Board of Zoning and Planning

Staff Report

August 24, 2023

1) Application Number: BZAP-23-16 – **Tabled from July 27, 2023**

Site plan

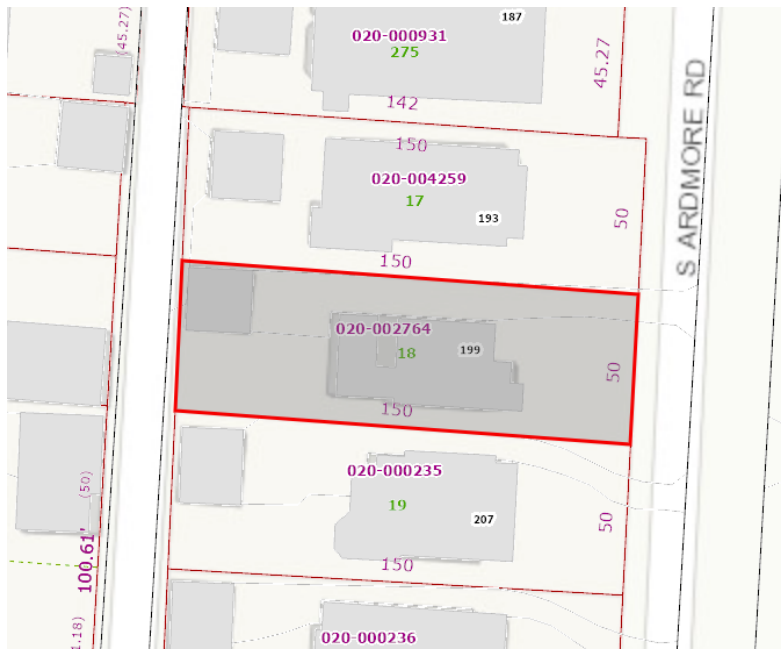
The fence was installed along the side yard in the rear yard, when the fence permit was applied for. After determining this was a corner lot and what was installed did not meet the setback and/or height limits. The applicant was informed that the fence could be modified to meet code or the owner could consider a Special Permit, subject to Board review. The applicant submitted a BZAP application the next day.

The applicant has provided a fence which meets the criteria. If the Board finds it appropriate to grant a Special Permit The property line is approximately 3' behind the sidewalk, which will determine if our staff Landscape Consultant can review the landscape or if the Tree & Public Garden Commission will need to review it, if within the right-of-way.

The only other concern is the proximity of the fence to the driveway entrance; however, it has been in place for a couple of weeks and would only affect the owner when backing out of the property. If it has not been a problem as of yet, it may fine to allow it in the current location.

Site Plan

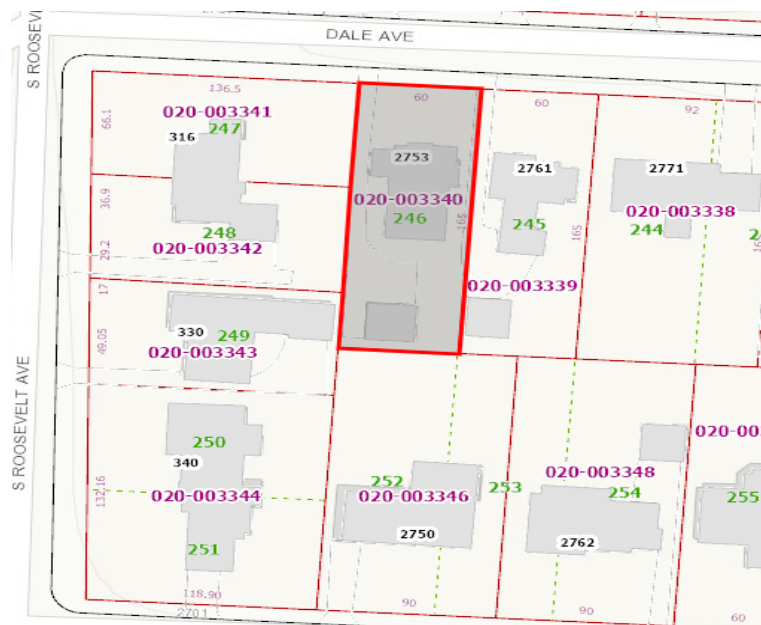
Bexley code Section 1252.15 Accessory Uses and Structures limits accessory structures to 624sq' for lots that are 6,000 to 13,999 square feet. The property in question is 7,500 square feet and has an existing 360'sq' (20' x 18') garage. Code allows a 624sq' garage.

The owner would like to replace the garage with a slightly larger garage (616sq') that has a 2nd floor dormer. Being all of the other code requirements will be met, the applicant is seeking a Special Permit to allow a functioning dormer and also a certificate of appropriateness.

This went to the Architectural Review Board for design review and received a recommendation to the Zoning Board for a certificate of appropriateness, with the condition that the eave details be refined to match the house. There was mention that the applicant may consider the north side setback, which is t 3'; however, code does not require additional setback unless the dormer is outward facing. The proposed dormer faces the interior of the applicant's yard. The eave modifications have since been made and added to the application. If the Board finds it appropriate to grant a Special Permit, staff has no further conditions, but will defer to Karen on any further design details she finds necessary.

Existing site plan

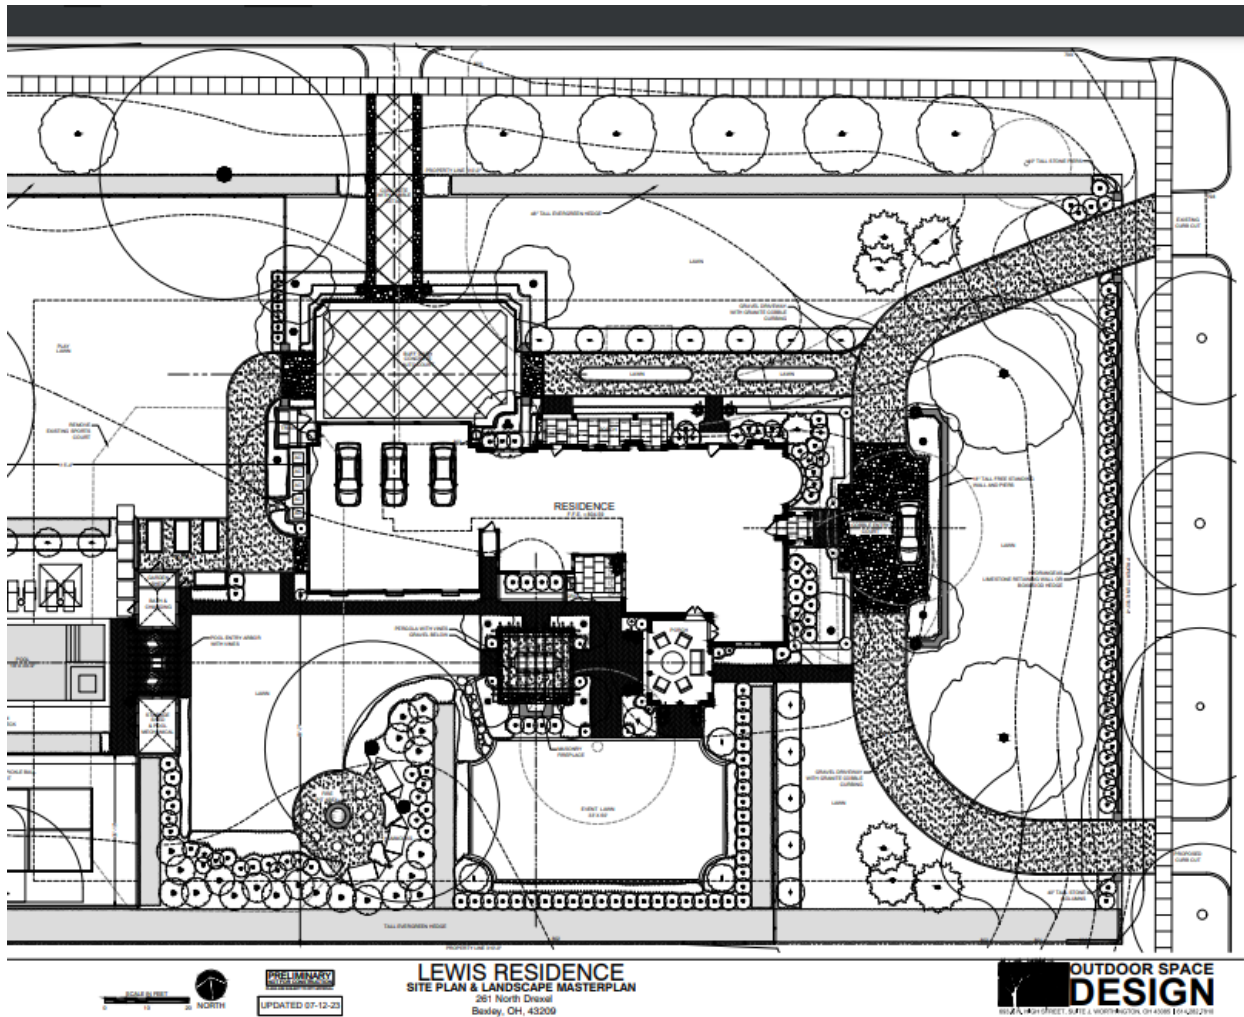
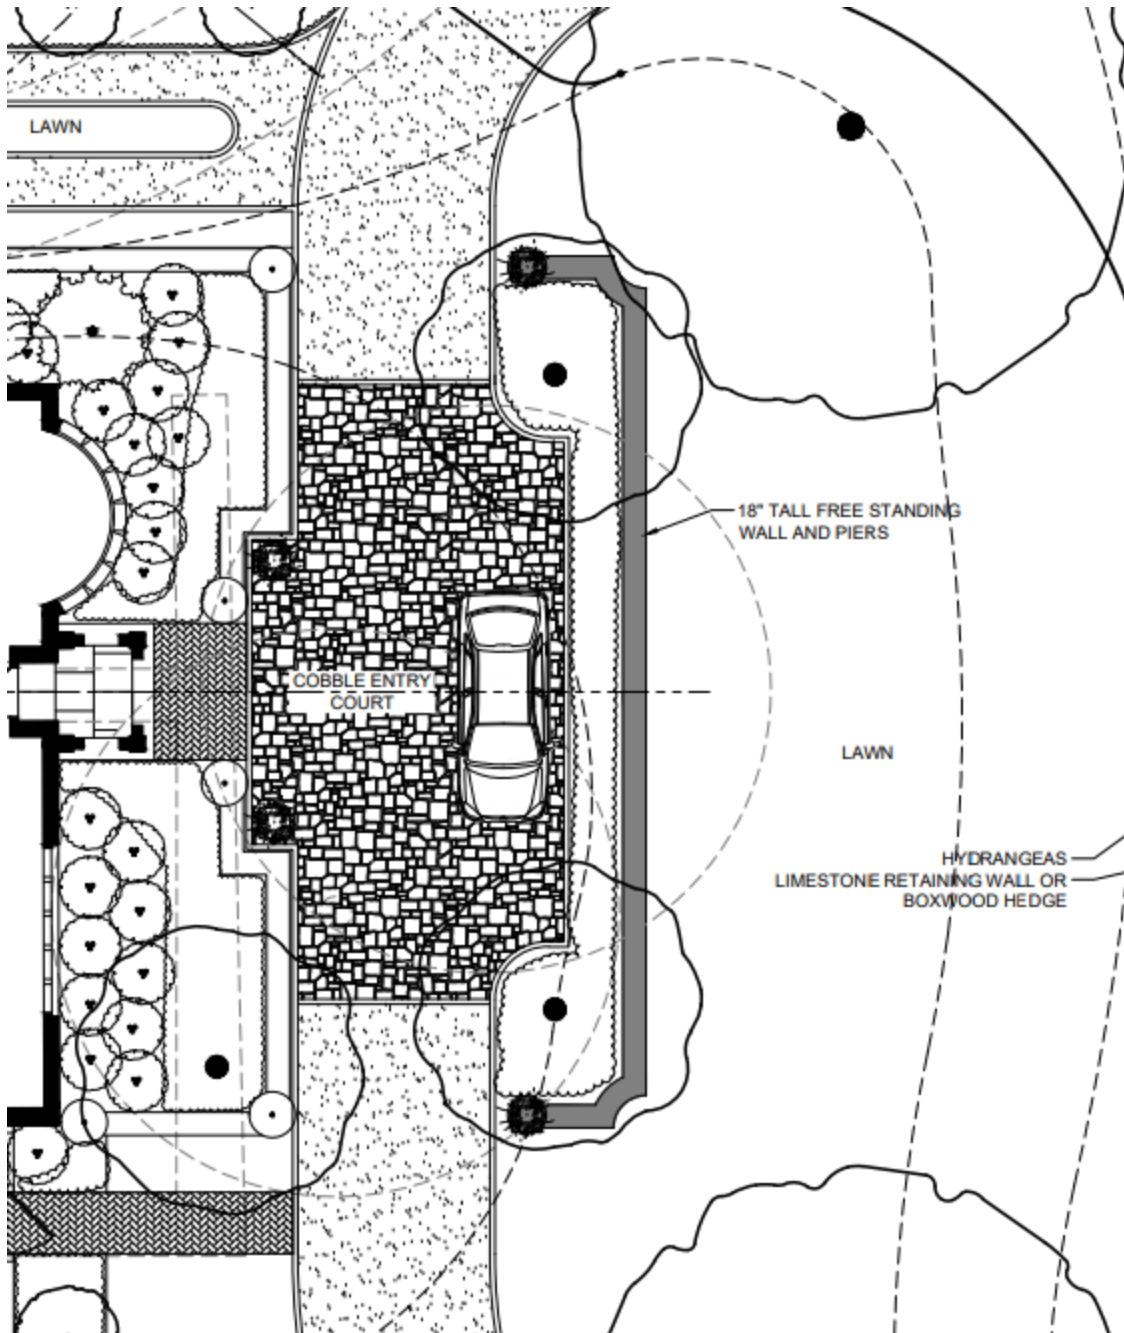
The proposed expansion is centered on the driveway at the front entry. It technically requires a 5.5' variance for the portion that widens along the east side of the driveway, for a distance of 30'. The applicant also has a low free-standing wall proposed along the outside of the drop-off area.

The applicant will provide a landscape plan for the exterior side of the free-standing wall which would additionally screen the expanded driveway area.

This is not uncommon to see the expanded drives in the district and it is requested for drop-off purposes. If the Board should find it appropriate to grant a variance, it should include conditions: 1) that it not be used for overnight parking and 2) a landscape plan to screen the drop-off area, subject to further review and approval by the Landscape Consultant.

Aerial of house at 1-11 S. Remington

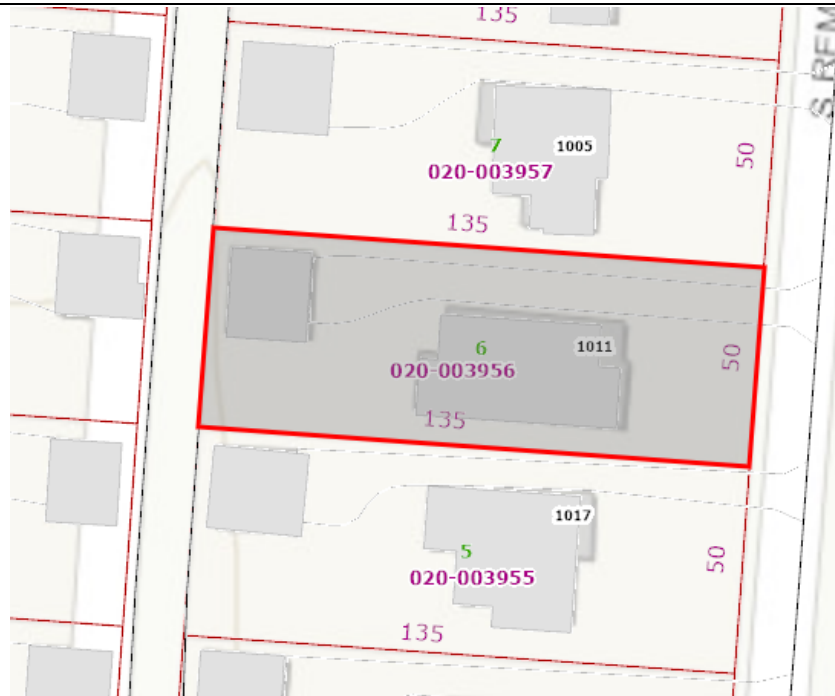
There was an application received under a Minor Architectural Review application which included a 16' x 16' hip roof timber frame pavilion over an existing patio. The new structures roof was close enough for the roof to overhang the house roof. Staff did not find the proposed manner in which it was located to be ideal or it may not function properly in situations such as snow accumulating where the structures overlap.

The Design Consultant had concerns of the overall appearance. We suggested the applicant pull the structure further from the house; however, the applicant was trying to center the structure over an existing paver patio. We also suggested an addition instead of the free-standing structure proposed.

The applicant has submitted a porch roof addition as well; which if approved, would require a 2.2' variance from the required 8' setback from the side property line under code section 1252.09. The pergola – as a free-standing structure is required to be 3' from the side property line.

Staff will defer to the Board on the appropriate design. This has not been before the ARB and if the BZAP finds either design to be appropriate – final design review of the porch roof addition can be deferred to the ARB on September 14th, or to the Design Consultant for the detached pergola, based on any recommendations from the BZAP.
